Access Compliance Report

Public Rights-of-Way

(Curb Ramps)

Intersection ID: 17415	Main Street: BREITLING GROVE PL	Cross Street: VISTA DR	Location: NE
ADA ID: 58422CAFA57F	Ramp Type: PerpDiag	Initial Pass/Fail: Fail	Overall Compliance: No
Severity Score: 12.5			
Codes/Mitigation Info/Possible Solution		Field Measurements/Component Compliance

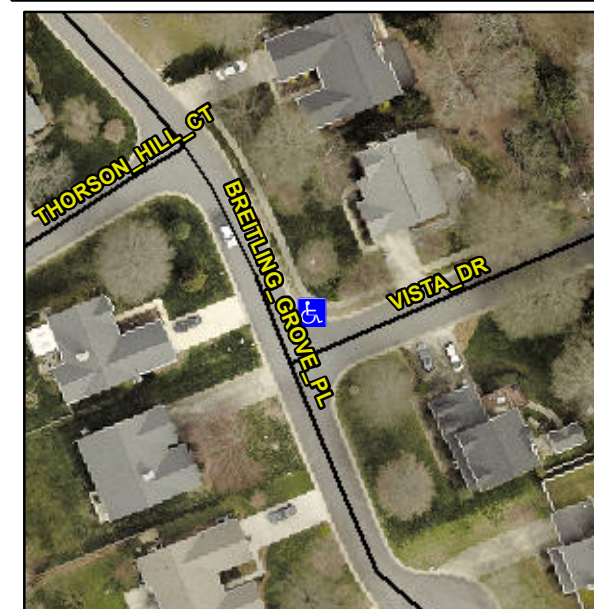
R304.5.3

Compliance	Description	Data	Compliance	Description	Data
N/A	Ramp Length (in)	44.0	Yes	Ramp Slope (%)	7.5
Yes	Ramp Width (in)	48.0	No	Ramp XSlope (%)	5.9
N/A	Flare Type LT	N/A	N/A	Flare Type RT	N/A
N/A	Flare Slope LT (%)	N/A	N/A	Flare Slope RT (%)	N/A
N/A	Flare Traversable LT?	N/A	N/A	Flare Traversable RT?	N/A
N/A	Landing Length (in)	N/A	N/A	DWS Provided?	N/A
N/A	Landing Width (in)	N/A	N/A	DWS Contrast?	N/A
N/A	Landing Slope (%)	N/A	N/A	DWS Length (in)	N/A
N/A	Landing X Slope (%)	N/A	N/A	DWS Full Width?	N/A
N/A	Landing Curb? (Y/N)	N/A	N/A	DWS Offset (in)	N/A
N/A	Shared Landing?	N/A			
N/A	Gutter Ponding?	N/A	N/A	Gutter Slope (%)	N/A
N/A	Gutter Lip Ht (in)	N/A	N/A	Gutter X Slope (%)	N/A
N/A	Painted X Walk1?	No	N/A	Painted X Walk2?	No
	X Walk 1 Direction	To W		X Walk 2 Direction	To S
N/A	X Walk 1 Width (in)	N/A	N/A	X Walk 2 Width (in)	N/A
	X Walk 1 Slope (%)	4.6		X Walk 2 Slope (%)	1.8
	X Walk 1 X Slope (%)	3.0		X Walk 2 X Slope (%)	5.0

Remove & Replace Curb Ramp With Two New Directional Ramps or Equivalent.
